7 February 2020

Australian Energy Market Operator - Consultation Paper on key Forecasting inputs in 2020 – December 2019

Figure 3-13 Projected capital costs for batteries by scenario compared to previous studies

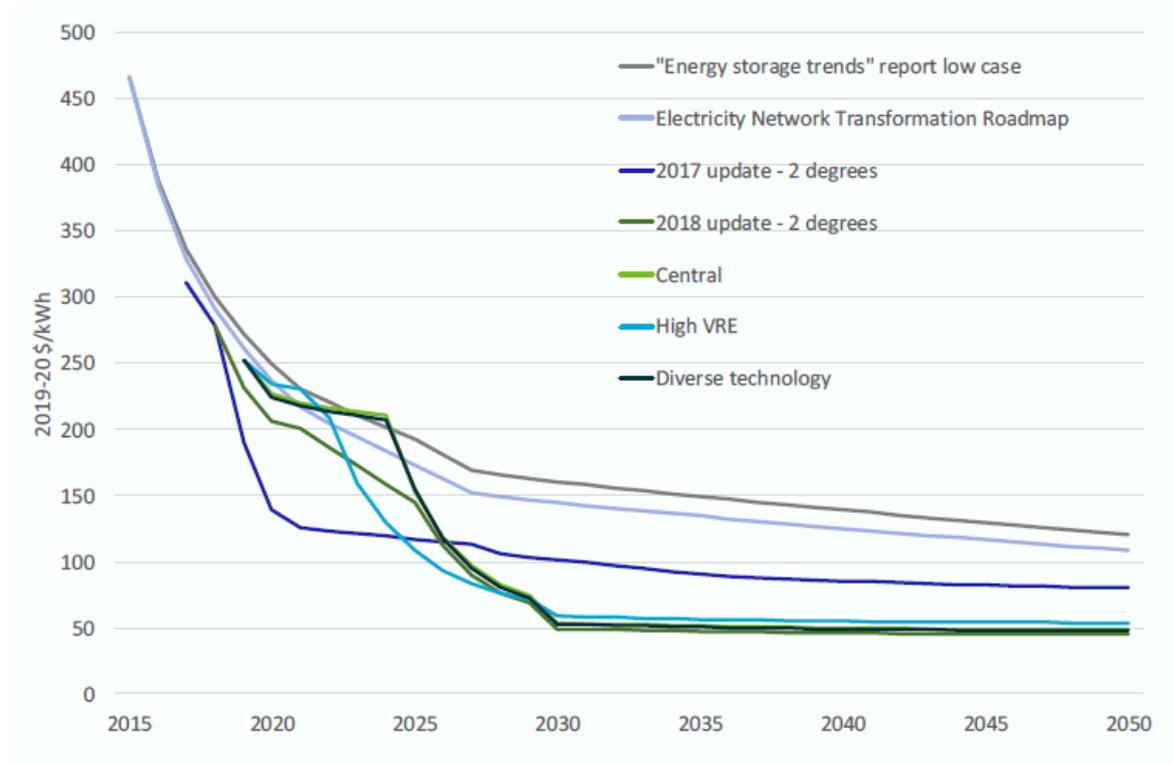
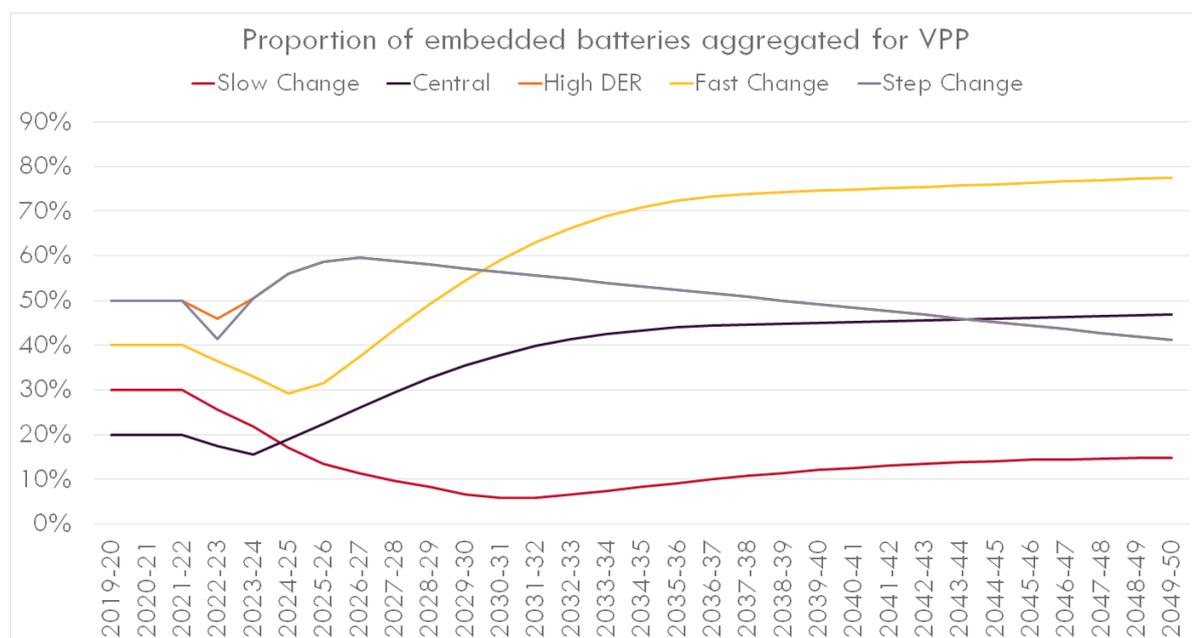
Forecasting technology cost reduction curves is an inexact science, especially when global volumes will be a key driver of learning curve reductions. We would strongly suggest that a more divergent range of capex costs for batteries are developed for future use (including under RIT-Ts). The examples below from AEMO's assumptions workbook and CSIRO's most recent GenCost analysis illustrate this lack of diversity.

On the basis of the 2018 CSIRO and GHD estimates, AEMO’s Fast and Step Change scenarios have higher battery capex assumptions than other scenarios. This appears directionally inconsistent with technology-led scenarios, where technology innovation and cost reductions are typically considered key drivers of technology disruption. We would also question why costs plateau so strongly from 2030 onwards.
